CERTIFICATE OF APPROPRIATENESS ISSUED: June 11, 2024 EXPIRATION: June 11, 2025

This letter provides you with confirmation that the proposed changes to your designated Fort Collins landmark property, the Colorado and Southern Freight Depot and Docks at 250 N. Mason St., have been approved by the City's Historic Preservation Division because the proposed work meets the criteria and standards in Chapter 14, <u>Article IV</u> of the Fort Collins Municipal Code.

- 1) Replacement of EPDM roof material with TPO
- 2) Addition of overflow scupper on east side of building; related relocation of power system (currently under overflow scupper location)
 - a. Overflow scupper should match the existing scupper with collector and downspout assembly.
- 3) Masonry repair on inside of brick parapet wall, including tuckpointing, using type N mortar matching the appearance of the existing, and replacement of deteriorated bricks.
 - a. Ensure that replacement bricks match the existing material.

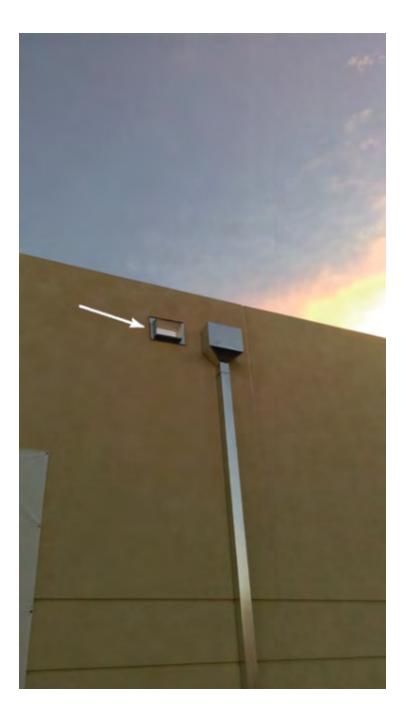
2) we add an overflow scupper. The concern is that if the one existing scupper becomes blocked/clogged we are essentially forming a pool on the roof and this building is not engineered to hold that much weight. Current codes require the secondary/overflow scupper for all new roofs as a safety factor in case debris/materials were to prohibit the function of the main roof drains. Below is what a standard overflow scupper would look like next to the existing scupper and downspout. This will change the look of the east elevation of the building if installed.

Would you please provide a photo of the existing scupper/where the secondary scupper will go?

Attached is a picture of what the existing scupper looks like with a rough sketch of what would be added. I've also attached some additional photos of the roof and the inside face of the parapet wall – this is where all the deteriorated brick is located. When repairing the existing masonry we would use a standard N type mortar mix and try to match the look of the existing mortar as closely as possible. I also don't foresee us parging the interior face of the parapet wall as the roof assessment proposes.

Roof Section A Photo's depict failing roof due to shrinkage and delamination from substrate. This is common with older single ply roof membranes.

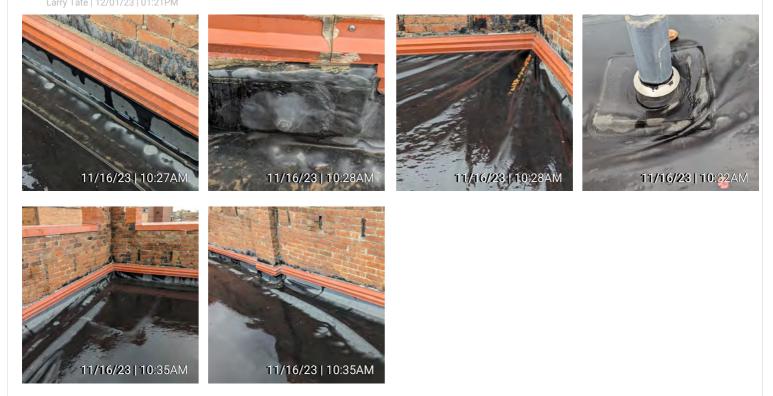
Roof Section A Masonry wall deterioration is advanced. Tuck point combined with Parge coat is some areas is highly recommended. Larry Tate | 12/01/23 | 01:22PM
